**Re: 1496
Herget Variance – Infiltration Trench**

**Re: 1496
Herget Variance - ADDENDUM**

**Re: 1496
Herget Variance**

Re: 1066
Herget Site Plan

STUDY
WATERSHED EXHIBIT

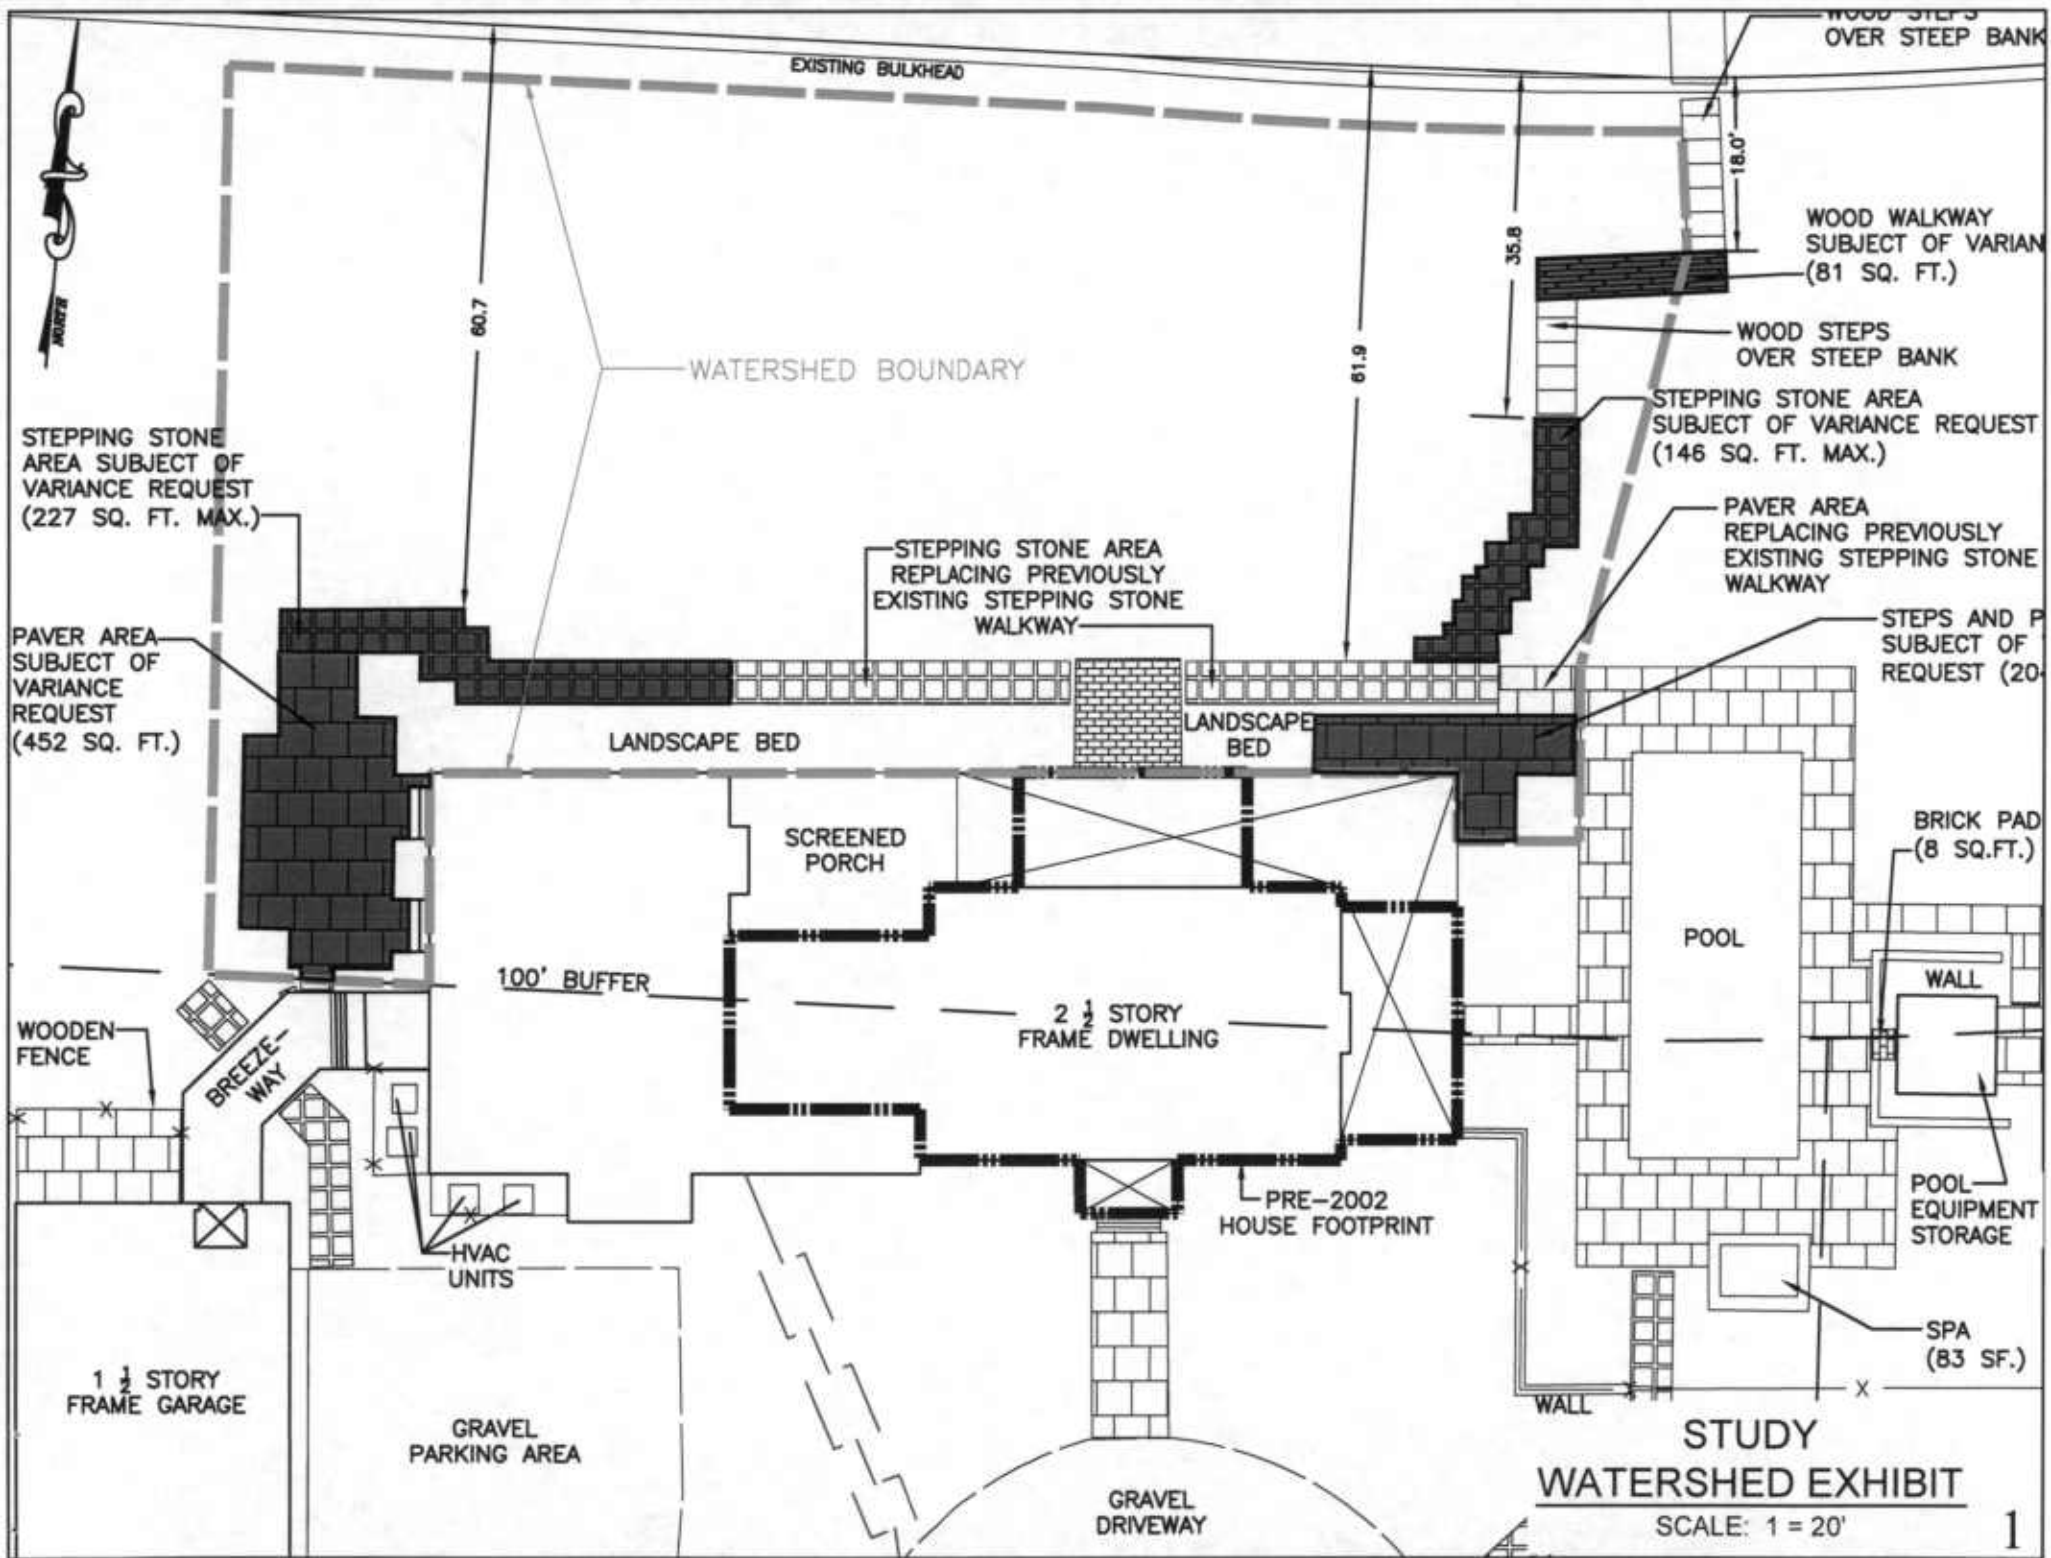
Sheet 1 depicts the Study Watershed (defined as the area draining from the pavers and impervious surfaces that are the subject of the Variance application); Sheet 2 shows a cross-section diagram indicating the drainage area and beyond with the proposed infiltration trench, and Sheet 3 show an infiltration trench detail BMP taken from the Maryland 2000 Storm Water Management Design Manual. Sheets 4, 5, 6 and 7 outline a summary and supporting computations utilizing the Chesapeake Bay Critical Area 10% Pollution Reduction formula (Option A as described above) to compute the reduction in phosphorous loading from pre compared post improvement conditions. The infiltration trench improves the quality of run-off leaving the site by 33% as demonstrated in the computations. Sheets 8, 9, 10 and 11 outline a summary and supporting computations utilizing the Chesapeake Bay Critical Area 10% Pollution Reduction formula (Option B as described above) to compute the reduction in phosphorous loading from pre compared post improvement conditions. The infiltration trench improves the quality of run-off leaving the site by 44% as demonstrated in the computations.

HERGET RESIDENCE · WATER QUALITY IMPROVEMENT
DIAGRAM
LE. LIC 6.2.08

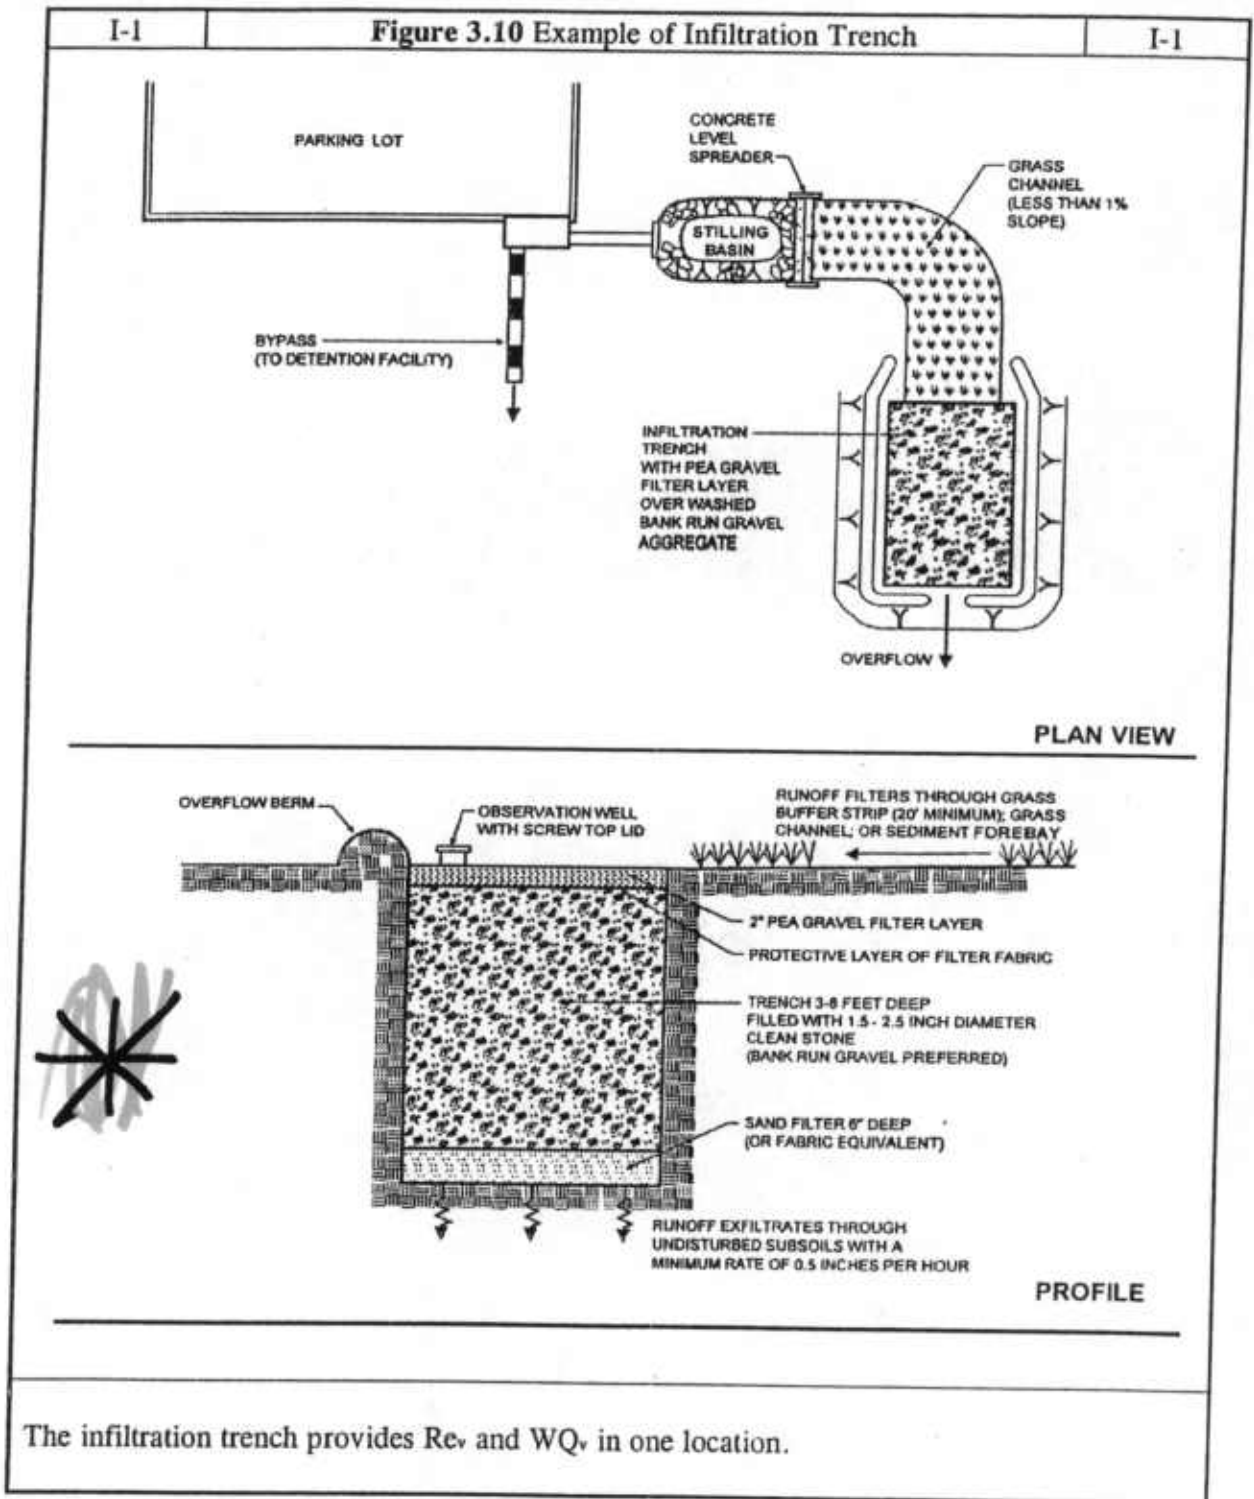
Sheet 12 utilizes the MD 2000 Storm Water Management Design Manual (required ordinance) to determine the infiltration trench required to intercept and infiltrate the first 1" if rainfall from any given storm event. The Sassafras soils on-site permit (worst case) 0.52"/hour of infiltration. Based on this factor and others, the infiltration trench volume should be 179 cubic feet. We propose a trench 1.5' x 2.0' x 140' length = 450 cubic feet x 0.40 stone void capacity = 180 cubic feet of storage capacity provided.

The addition of a *Spartina patens* (Salt marsh hay) planting strip down stream of the infiltration trench has not been factored into the phosphorous removal formula referenced above. It will provide supplemental infill opportunities for excessive run-off, but is primarily intended to stabilize the collection berm and contain the slope run-off entering the infiltration trench, and to return a portion of the buffer to a native grass plant community.
